**Re:     *APA No. 2021-0075 (DEC #6-3038-00081/00003)***  
***Comments of The Adirondack White Lake Association***

The LA Group was retained by the Adirondack White Lake Association (AWLA) to review the permit applications for the proposed White Lake Granite Quarry (quarry, mine) to determine if their concerns with the proposed mine were adequately addressed. These comments on the proposed White Lake Granite Quarry permit applications are submitted on behalf of AWLA.

The following are our comments on behalf of the AWLA on the permit application for APA Project No. 2021-0075.

## White Lake Granite Quarry Review - Figure 1

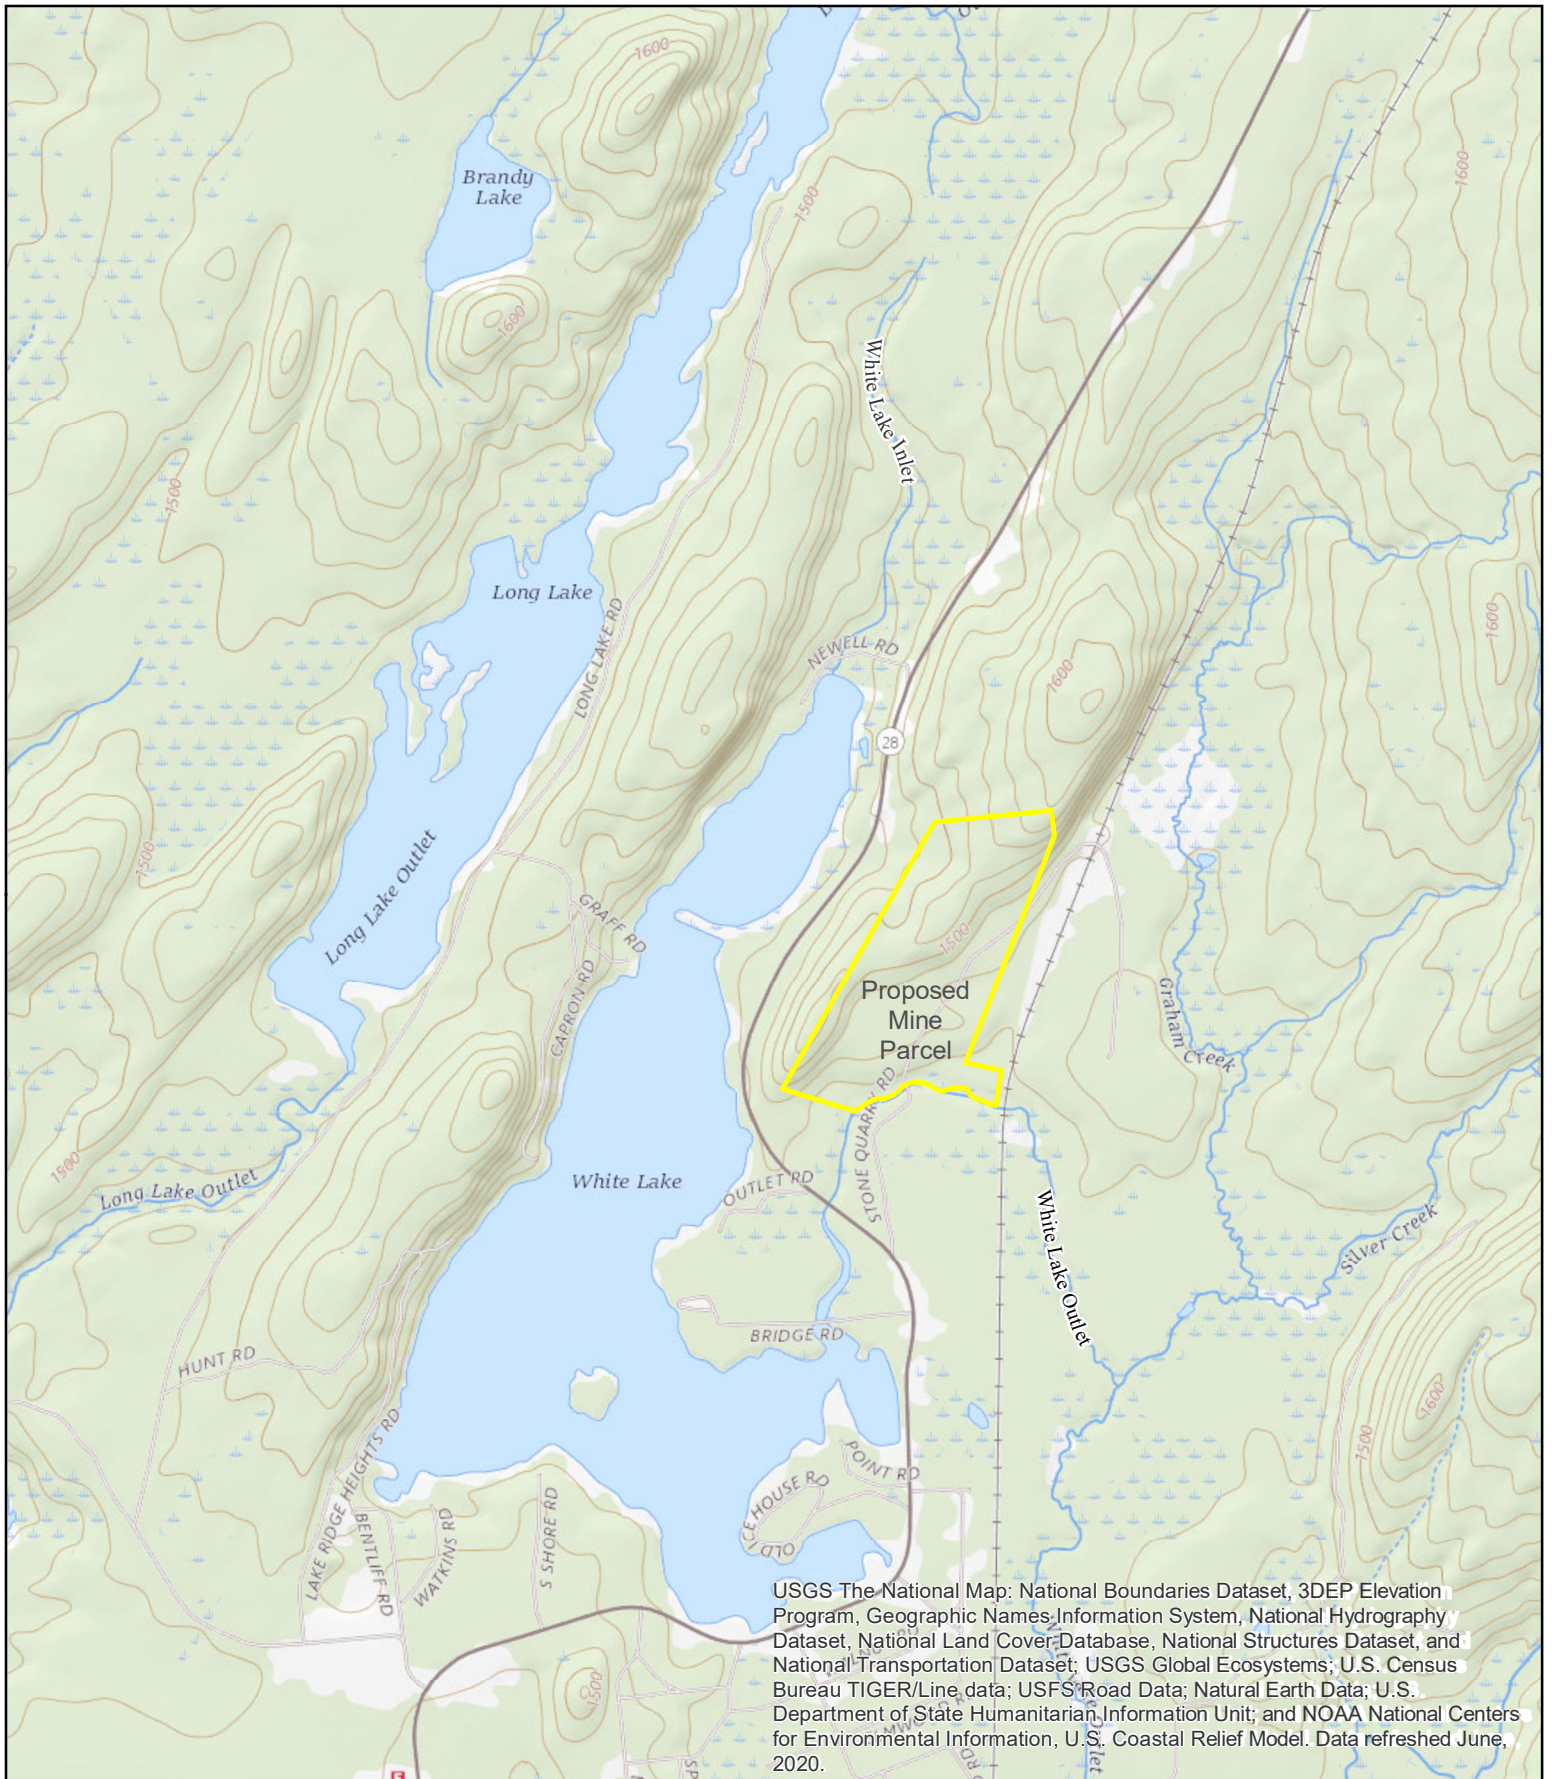
**A. The application record does not substantiate the applicant's claims of separation between the lowest proposed mine floor elevation and groundwater on the site because the applicant has not adequately documented where groundwater is located below the proposed mine. This information is critical to assessing potential impacts to hydrogeology.**

The following statements, some of which are inconsistent, are included in the record:

- *Proposed mining operations will occur above the water table in consolidated bedrock.* MLUP p.3
- *Proposed terminal depth of excavation is 1445 ft. roughly 5 to 10 feet above the water table.* MLUP p.4

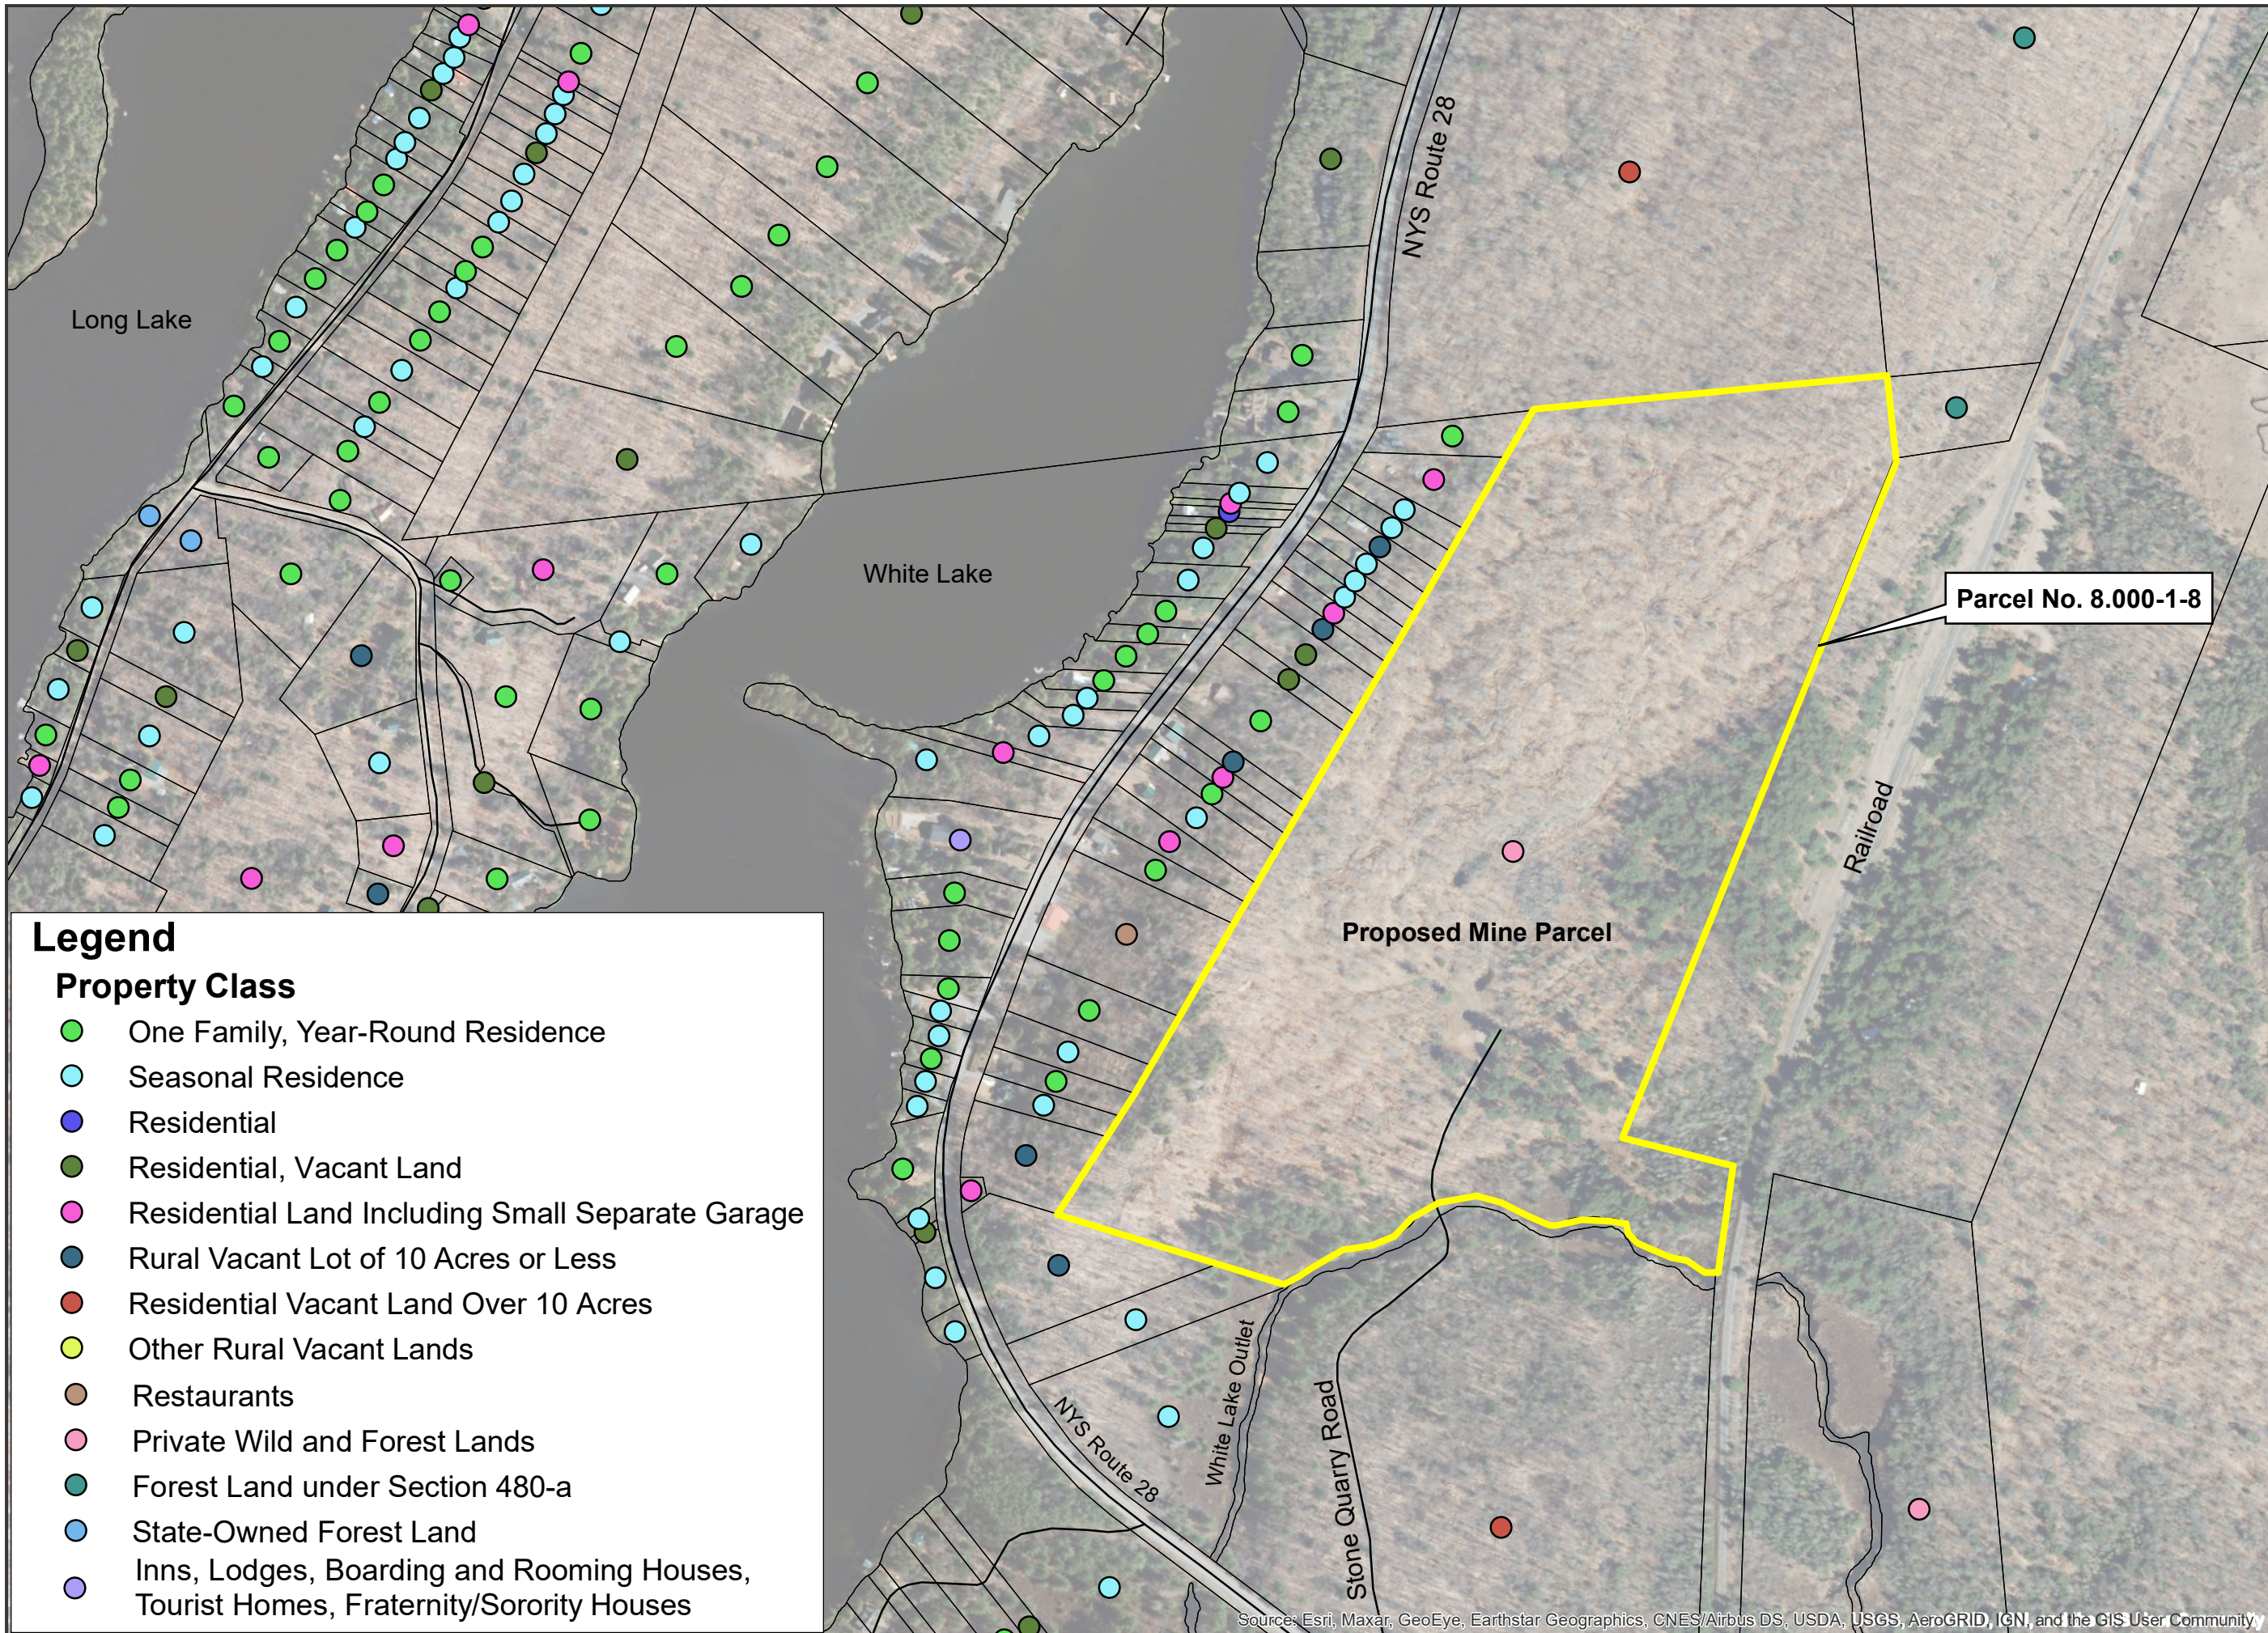
**A. It is imperative that the ambient noise environment is correctly characterized as it serves as the baseline against which mine-generated noise is compared in order to determine the potential for adverse impacts to the park's aesthetic resources. The current use of NYSDOT traffic data to characterize the existing noise environment is not appropriate. A noise impact assessment based on measured ambient sound levels must be part of the application record.**

The application correctly states that the noise environment in the closest residential area is dominated by vehicle traffic on NYS Route 28. The MLUP establishes an ambient noise level of 58 dBA based on NYSDOT average annual daily traffic (AADT) data. Because the mine is proposed in area dominated by residential uses (see Figure 2, Nearby Parcel Land Use Classifications), actual ambient noise levels need to be established via measurements taken in proximity to sensitive receptors in the vicinity of the proposed mine. DEC's Program Policy for Assessing and Mitigating Noise Impacts (page 11) states: *Most objective attempts to assess nuisance noise adopt the technique of comparing the noise with actual ambient sound levels or with some derived criterion.* The proximity of the mine to nearby concerned landowners (under 600 feet for some) dictates that collection of sound data is imperative to the review of this project. The DEC Noise Program Policy then goes on to state *if there is any concern that levels based on performance values do not correctly reflect sound pressure levels, field measurements should be undertaken to determine ambient*
